California ISO

# **Reactive Power Requirements and Financial Compensation**

## **Revised Straw Proposal**

**October 8, 2015**

Figure 2: Proposed reactive power capability at different voltage levels

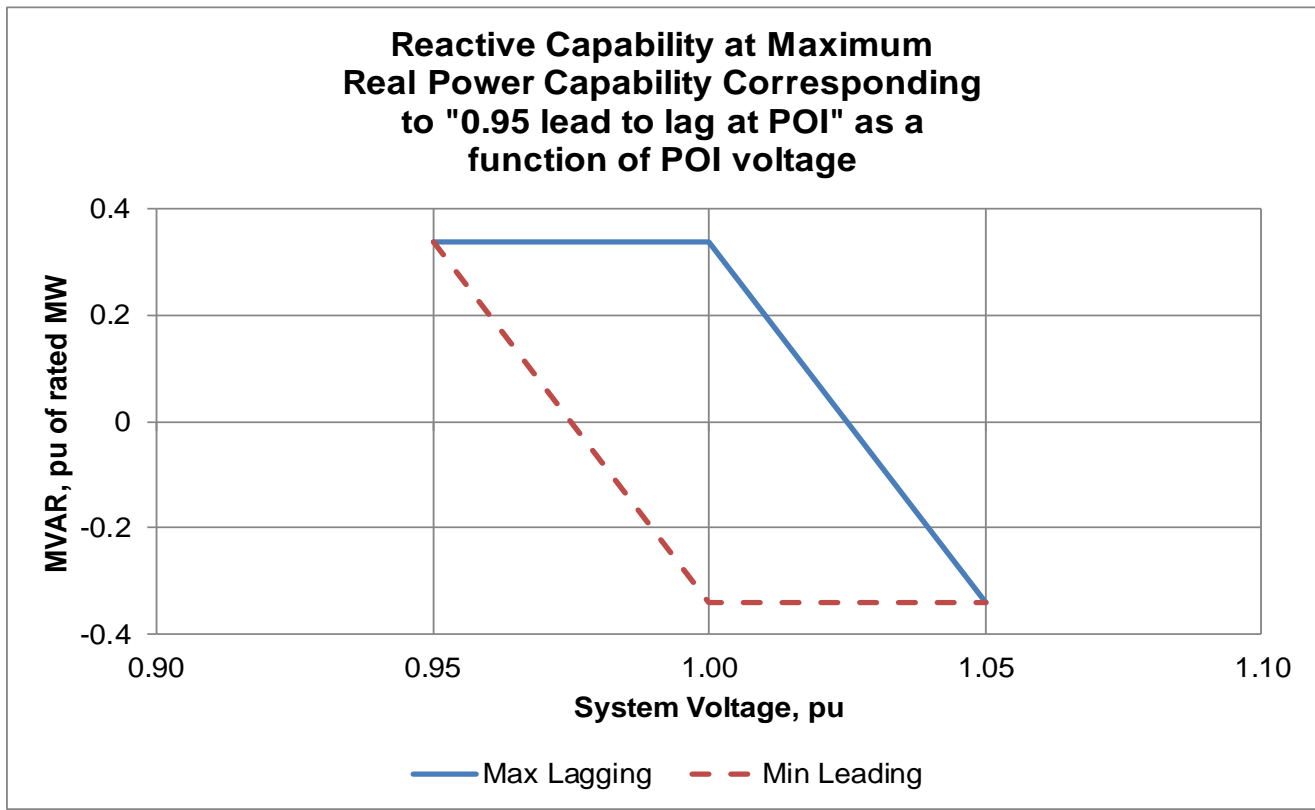
Comment: PG&E seeks clarity for continuous and dynamic reactive power requirement under different voltage levels (combination of figures 2 & 3).

Comment: CalWEA and AWEA note that the ISO was in agreement with CalWEA and AWEA at the stakeholder meeting of August 3, 2015 that the reactive power capability curve requirement for

an asynchronous generator (Figure 2) should be based on “actual MW” output and not “rated MW” output.

ISO Response: The ISO notes that there is a relationship between the similar Figures 2 and 3: Figure 2 shows the reactive capability needs with respect to per unit voltage. For example, for voltage levels between 0.95 per unit up to 1.0 per unit, the asynchronous resource should be able to

produce maximum reactive output through a combination of dynamic and static devices. Likewise, for voltage levels between 1.0 per unit and 1.05 per unit the asynchronous resource should be able to consume maximum reactive capability through a combination of dynamic and static devices. Figure 3 shows the reactive requirement for different levels of MW output. For example, at rated capacity, the resource should be able to provide approximately .175 per unit of dynamic reactive support. The transition from dynamic to static needs to be continuous. In other words, the transition needs to be continuous so that the dynamic and static capability will be provided in a continuous manner without waiting for the static response to kick in once the dynamic response is provided.

ISO Response: After additional review of Figure 2, the ISO disagrees and has confirmed that the Y axis should still be labeled: Per unit of “Rated MW”, and it is more appropriate to add “at maximum real power capability” to the title label of Figure 2. The diagram shows the maximum lead/lag reactive capability for voltage levels between 0.95 to 1.05 per unit at the POI. Figure 2 is a representation of the reactive capability at maximum real power capability, and is not intended to show the reactive capabilities at any other output levels.

Figure 3: Proposed reactive power capability for asynchronous resources

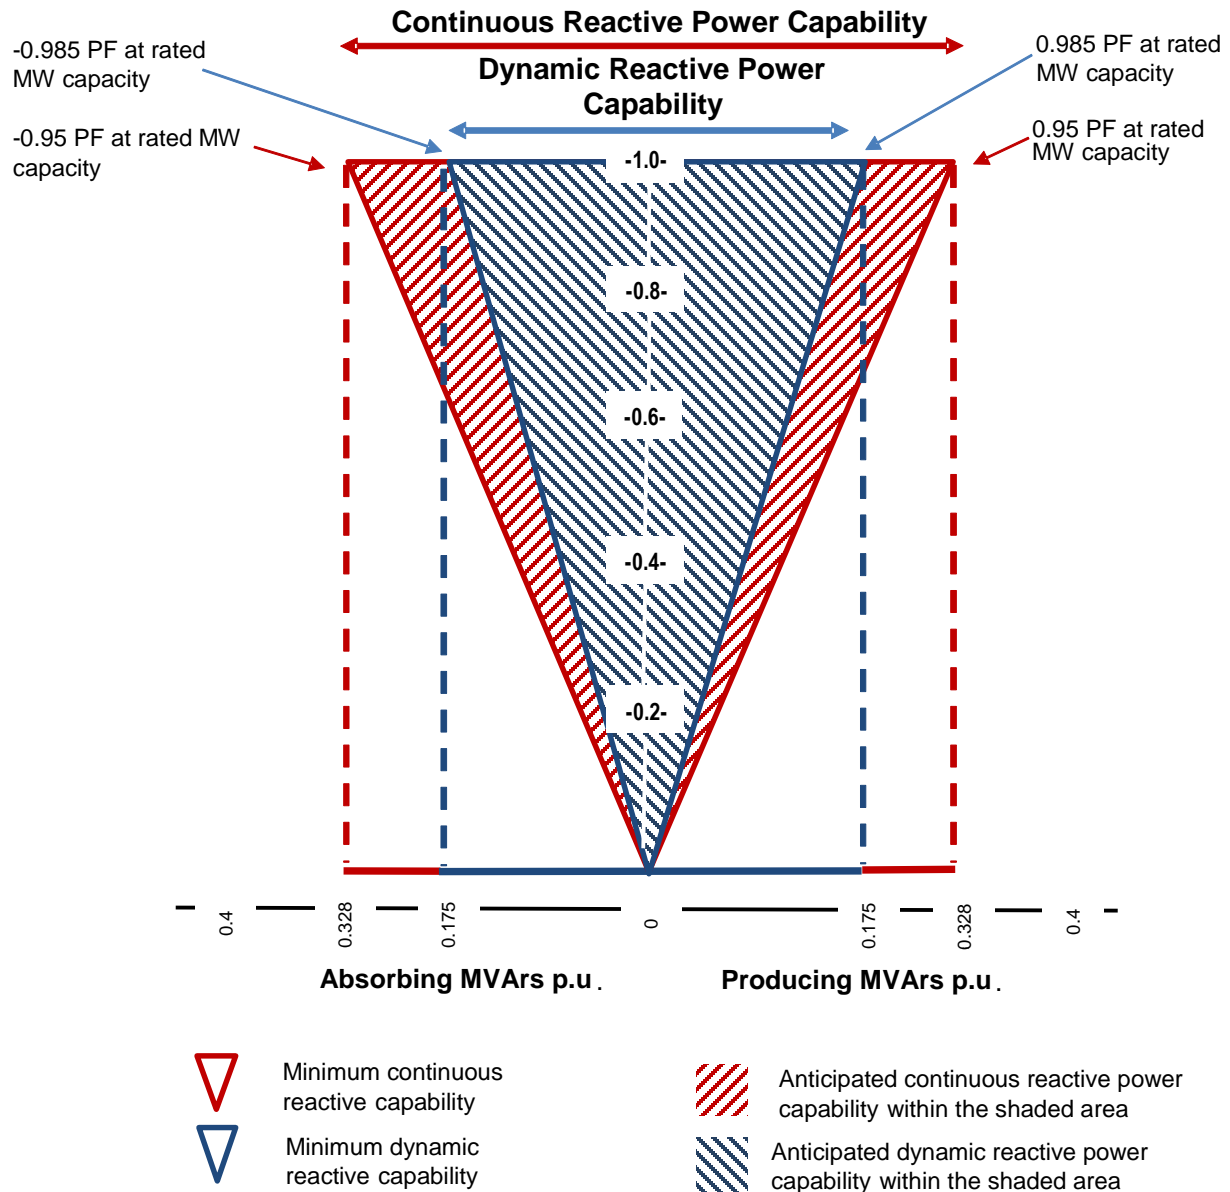
Comment: CESA asked; Will the CAISO need dynamic reactive capability for all MW levels at any time, or only when providing market services, e.g. delivering energy under an energy award? These detailed implementation concepts need review in order to avoid unintended risks of noncompliance and to inform planning and resource development.

Comment: PG&E believes that providing reactive power should be limited to a threshold active power output (e.g., 20% of the nominal resource output) as a must have capability for asynchronous resources.

ISO Response: Figure 3 of the ISO's proposal outlines the reactive support needed as the MW output of the unit changes. The ISO is not requiring reactive support when resources are off-line.

ISO Response: As noted above in response to CESA's comment on dynamic capability; Figure 3 of the ISO's proposal outlines the reactive support needed as the MW output of the unit changes. The ISO is not proposing requiring reactive support when the plant is off-line but will require some amount of reactive support throughout the full range of output when units are online.
